TOWNSHIP OF WELLINGTON NORTH

TO: Mayor and Council
DATE: 2024-09-23
MEETING TYPE: Open
SUBMITTED BY: Tammy Stevenson, Senior Project Manager
REPORT #: INF 2024-016
REPORT TITLE: Fergus Street North Reconstruction Update

Memo

Re: Fergus Street Reconstruction Design Update

TOWNSHIP OF WELLINGTON NORTH
FERGUS STREET RECONSTRUCTION
 Plan and Profile from Sligo Road to Sta. 0+600

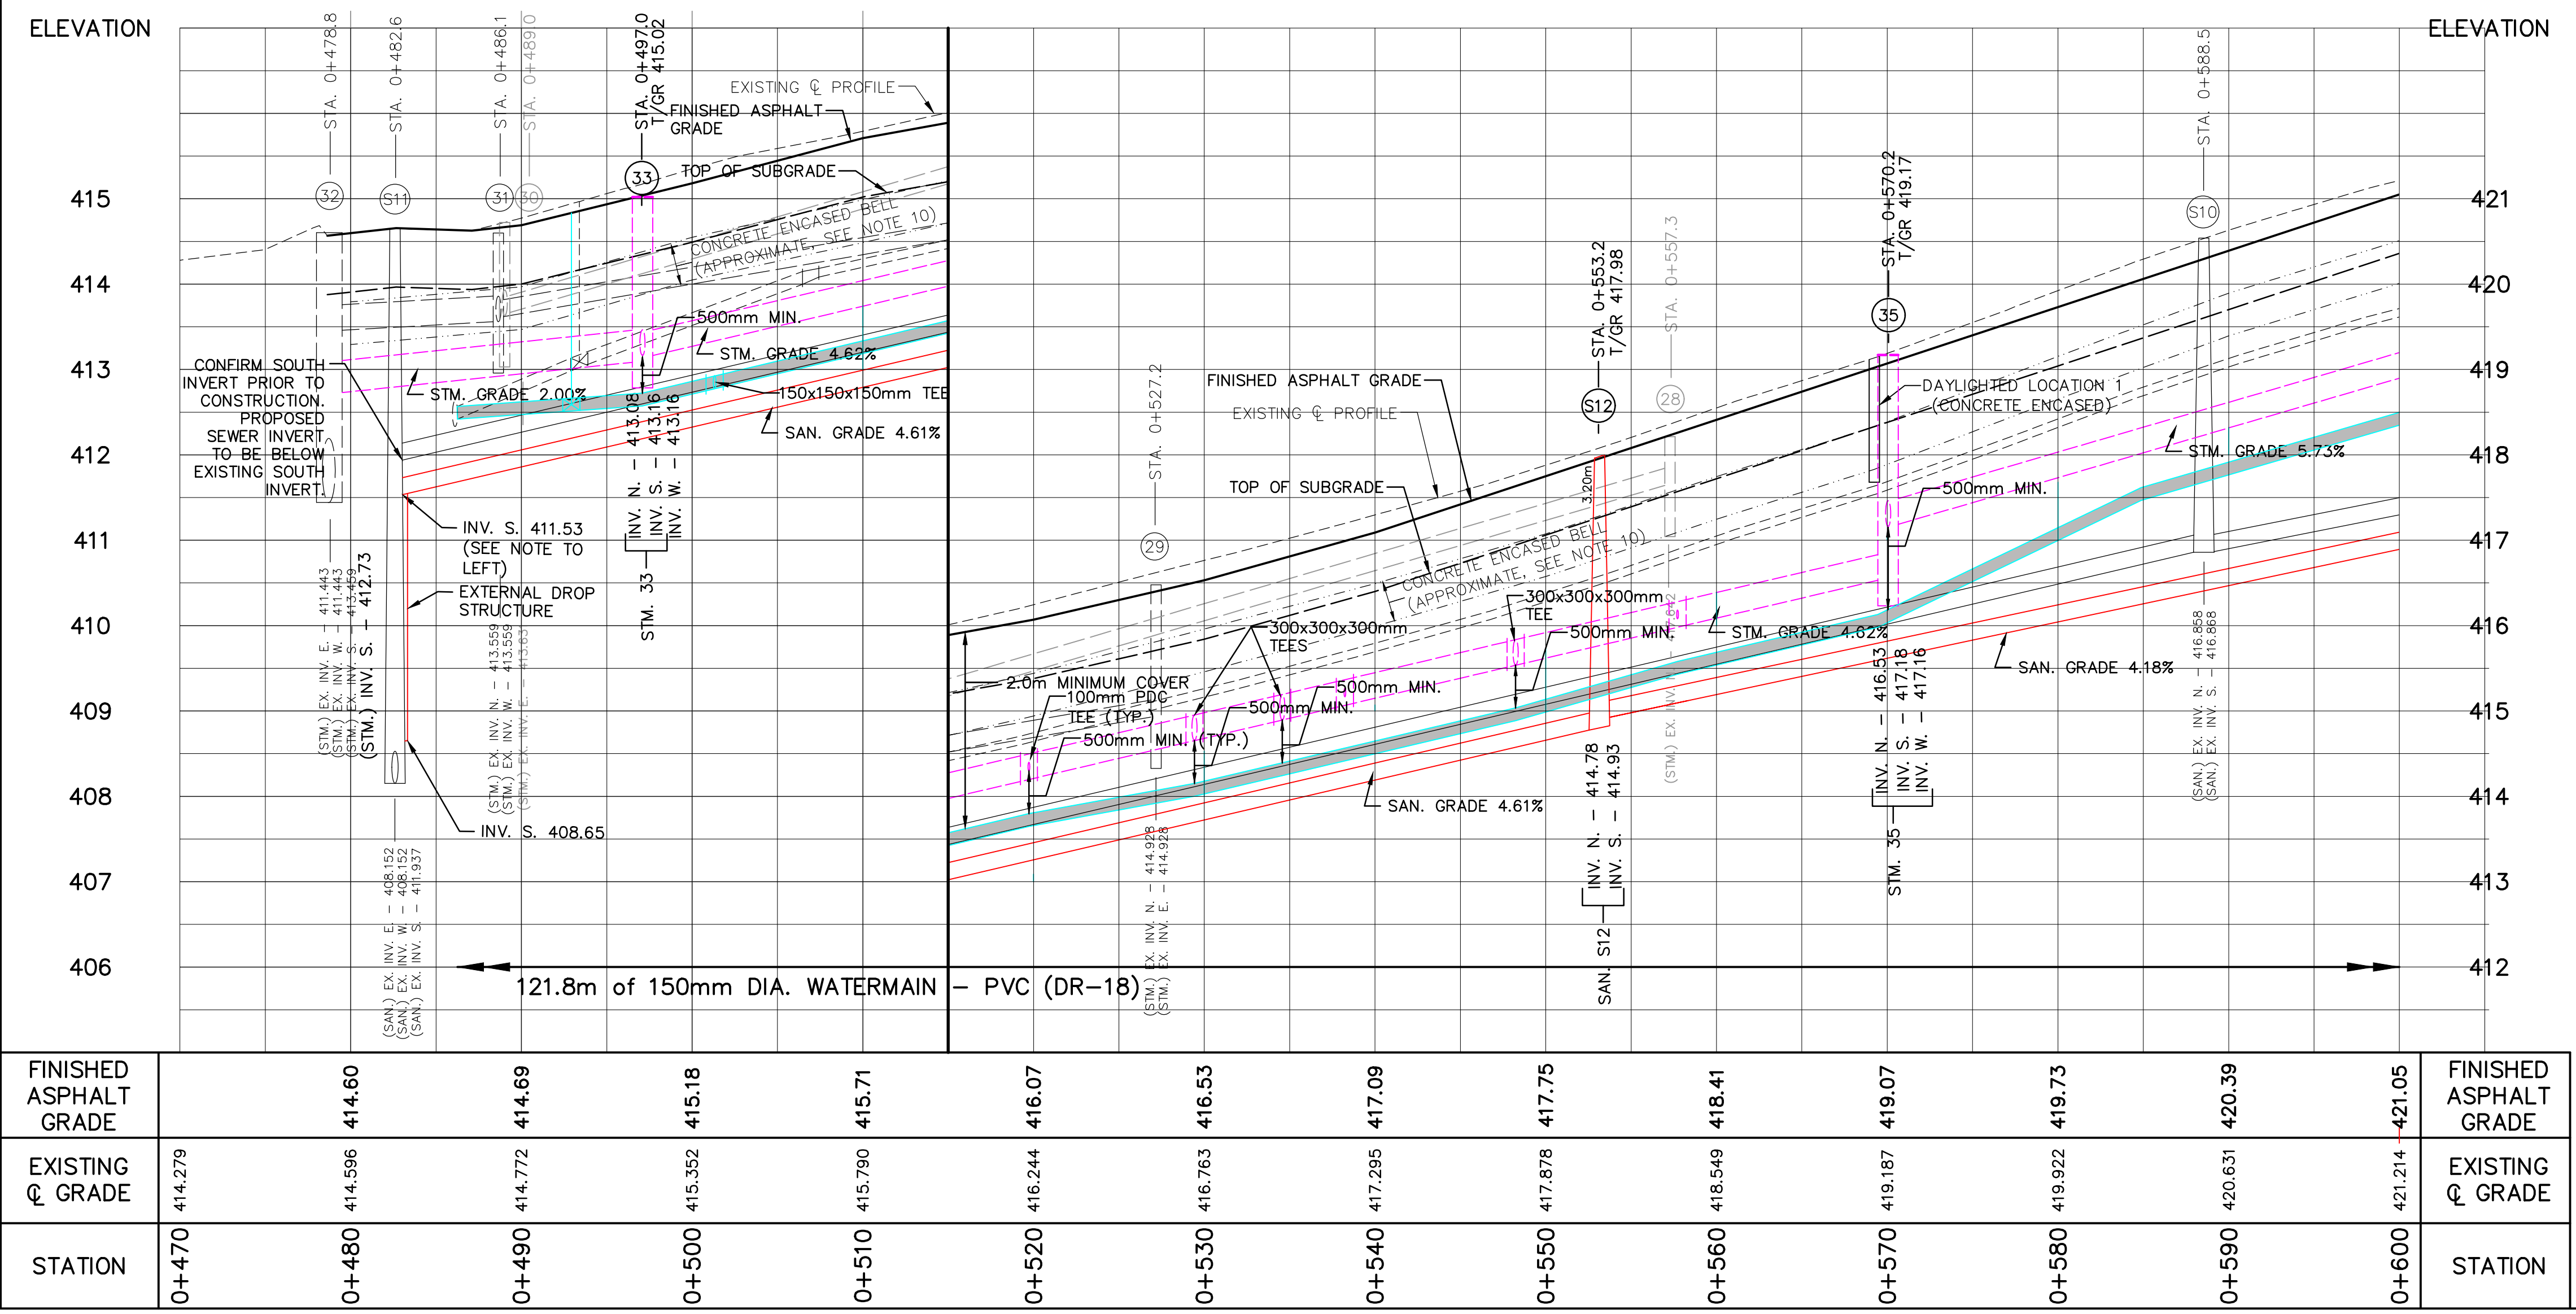
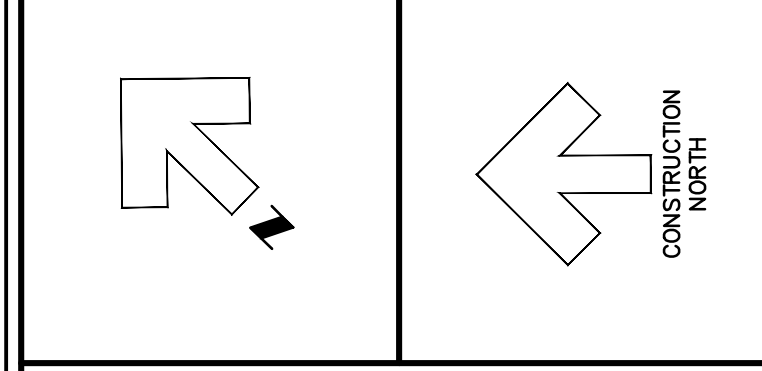
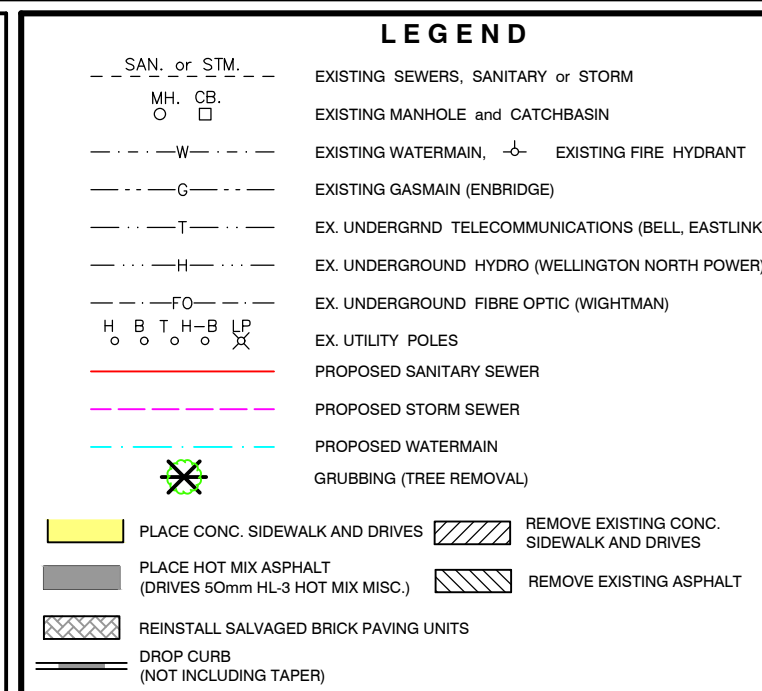
The tree conflicts noted in the preliminary drawings presented at the PIC in 2023 were mainly due to the location of the proposed sidewalk and the proposed layout of municipal services (water, sanitary, storm). It should be noted that since the project is a re-construction scenario, water and sanitary services are existing and any replacement services must connect to the existing utility on the private side; this fact practically limits the options for service placement. The proposed design illustrated sidewalk on the east side of the road for all three blocks, and an asphalt width of 8.5m as per Township standards. The servicing was drawn in general as per Township standards, and each service was designed to be placed perpendicular to the running line of the main line utility. This servicing approach is typically the most cost-effective, and operationally it is desirable to have straight service lines. As a result of the design approach noted above, the number of trees identified for removal were as follows:

- For all three blocks, the proposed sidewalk was switched to the west side of the road. This avoided conflicts with several large (1000mm+ trunk) trees along the Durham-Sligo block.
- For all three blocks, a non-standard design approach for servicing was implemented wherein service piping was permitted to be deflected on the private side of the right-of-way (ROW) within acceptable limits.
- For the Durham-Sligo block, the proposed road width was reduced to 7.5m from the standard 8.5m. As a result, parking on the east side of the road for this block will need to be prohibited.
- For a portion of the Durham-Sligo block, the running line of the proposed storm sewer was shifted to the west from the previous design to minimize damage to tree roots during installation.
